2538 Birch Street (formerly 1296 West Broadway)

Stephen Bohus, BLA
Vancouver resident and renter

What was referred?

This rendering was submitted in referred package

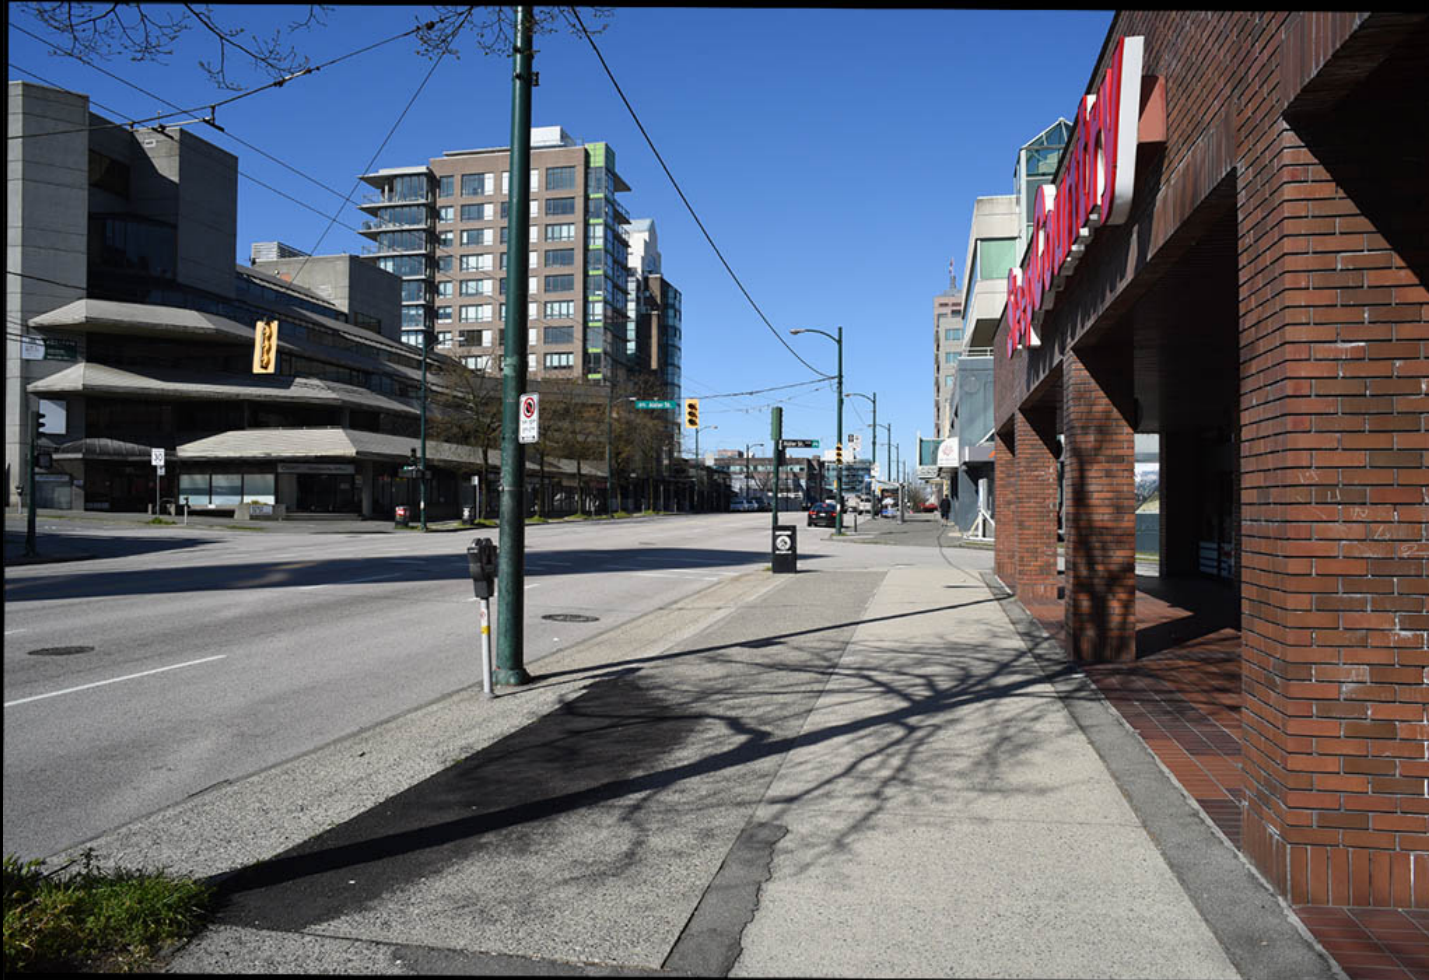
What is the focal length?

What is the 'before' state (for comparison)

What would it look like on a standard 50mm focal length?

Are there more choices in locations? (limited number in application)

Model at Open House

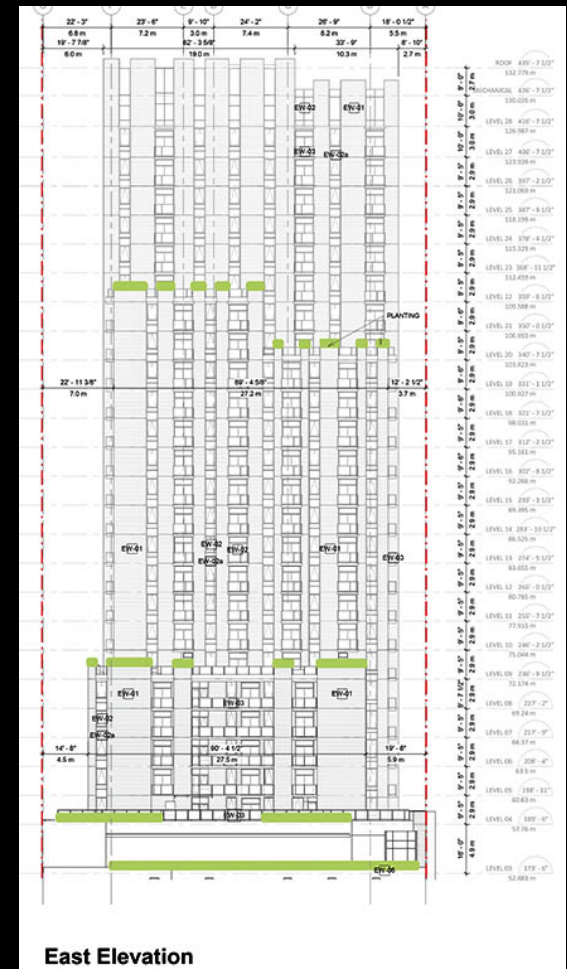
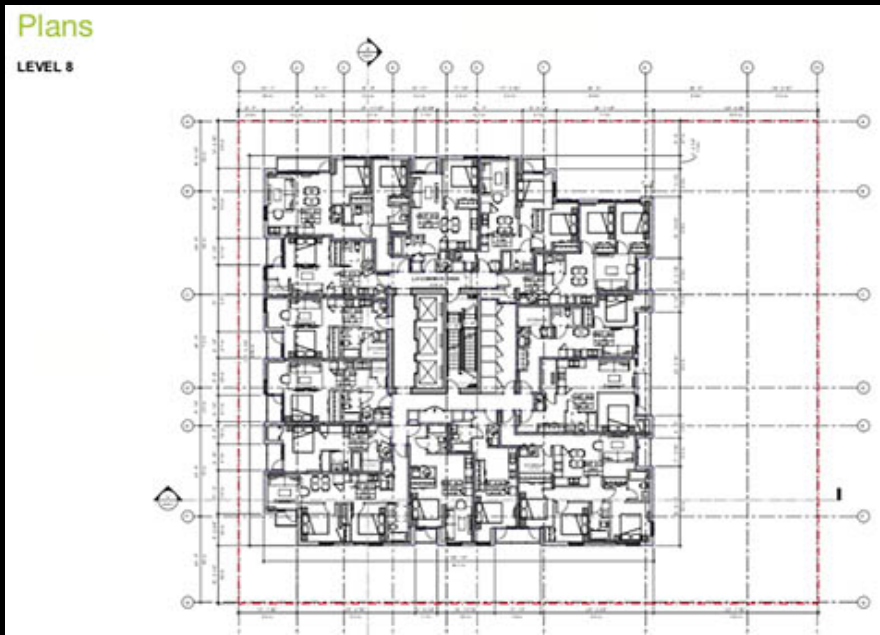
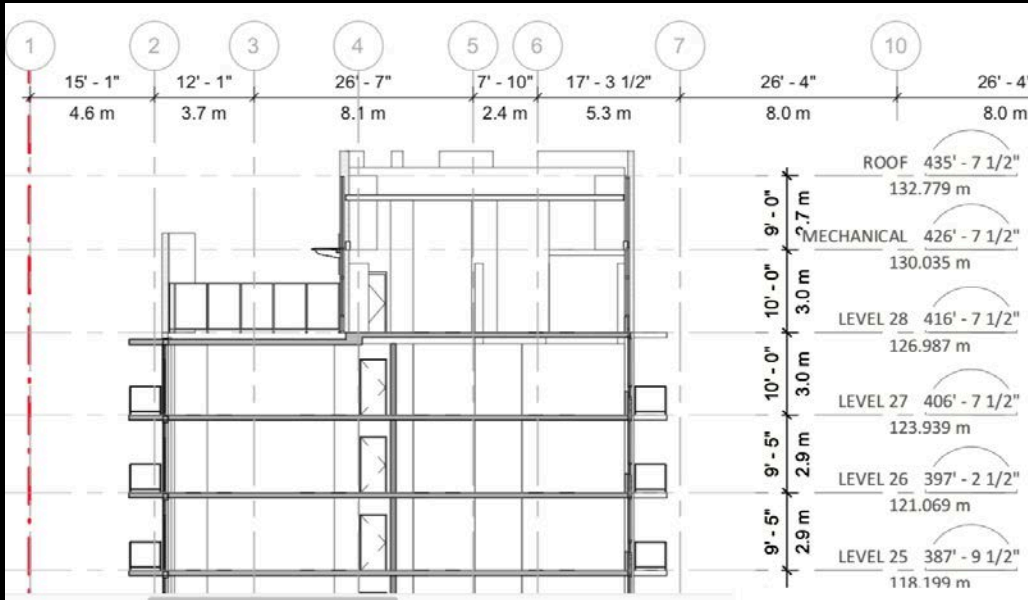
Photo not quite from grade with digital camera (wide angle).
How can one explore the space? Build a computer model.

Build a 3D massing model floor by floor (from plans, sections and elevations) to show general height, massing and scale.

Note: the applicant already has a computer model. It could be a simple 'save as' to export it (to file formats such FBX, Alembic, Collada, 3DS etc.) and submit it as part of the application.

Model at Open House

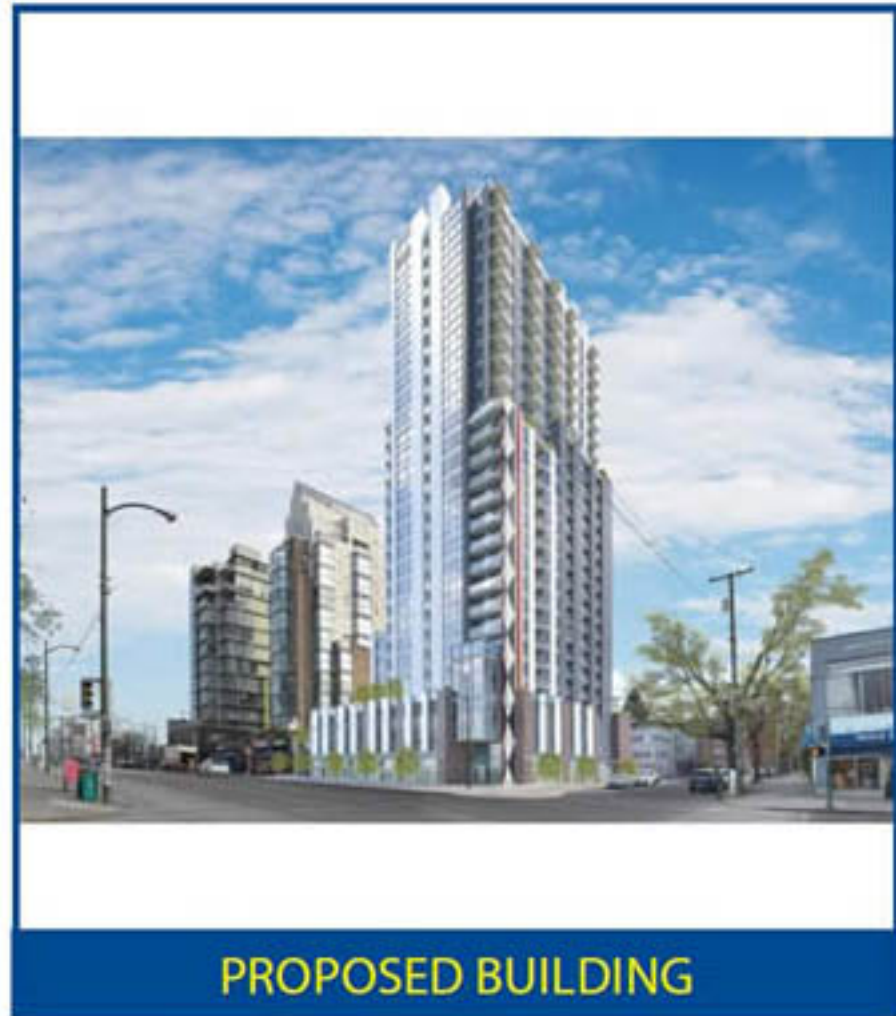
Wide angle photo not quite from grade with digital camera. Note difference in 3-point perspective in photo vs. rendering shown on City's Rezoning Centre page

This rendering was submitted in referred package. Used by staff on rezoning centre webpage and on information sign.

A number of open questions on choice and suitability of rendering.

What is the camera focal length (field of view)? Is it a true 3-point perspective? Can it be reproduced? Is this what a person would experience at street level? What is a 50mm photo look like instead?
